Project	IEEE 802.16 Broadband Wireless Access Working Group < <a href="http://ieee802.org/16">http://ieee802.org/16</a> >	
Title	Service Primitives for Location Update	
Date Submitted	2005-07-12	
Source(s)	Yun Won Chung, PhD Jee Hyeon Na, Sang Ho Lee, PhD ETRI, 161, Gajeong-dong, Yuseong-gu, Daejeon, 305-700, Korea	<a href="mailto:yun.chung@etri.re.kr">yun.chung@etri.re.kr</a> <a href="mailto:jhna@etri.re.kr">jhna@etri.re.kr</a> <a href="mailto:leesh@etri.re.kr">leesh@etri.re.kr</a> Voice: +82-42-860-5244 Fax: +82-42-861-1966
Re:	Call for Comment on P802.16g Baseline Document	
Abstract	This contribution proposes service primitives for location update.	
Purpose	The document should be considered during the resolution of comments on the baseline document.	
Notice	This document has been prepared to assist IEEE 802.16. It is offered as a basis for discussion and is not binding on the contributing individual(s) or organization(s). The material in this document is subject to change in form and content after further study. The contributor(s) reserve(s) the right to add, amend or withdraw material contained herein.

# Service Primitives for Location Update

Fig. 2 - Location Update Primitives

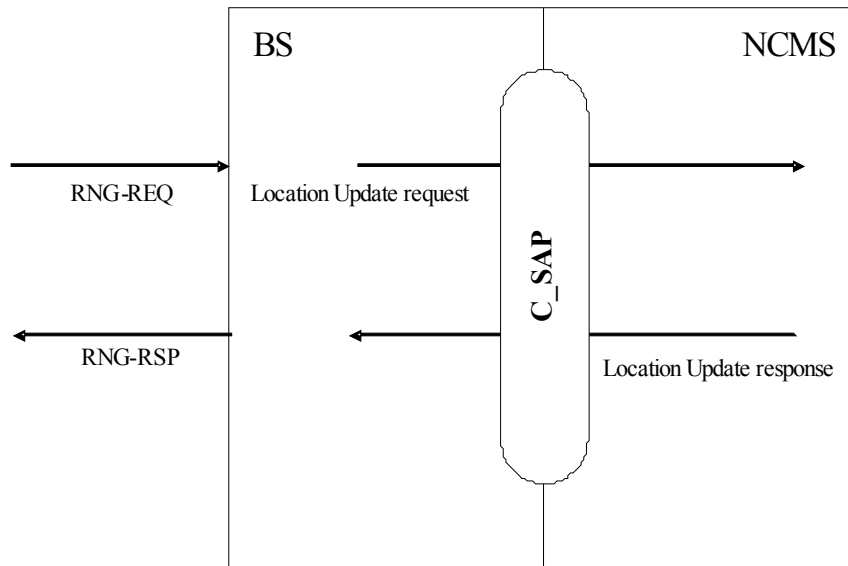
[Modify section 14.5.9.3 as follow]

Figure 2 shows service primitives for Location Update between a BS and an NCMS.
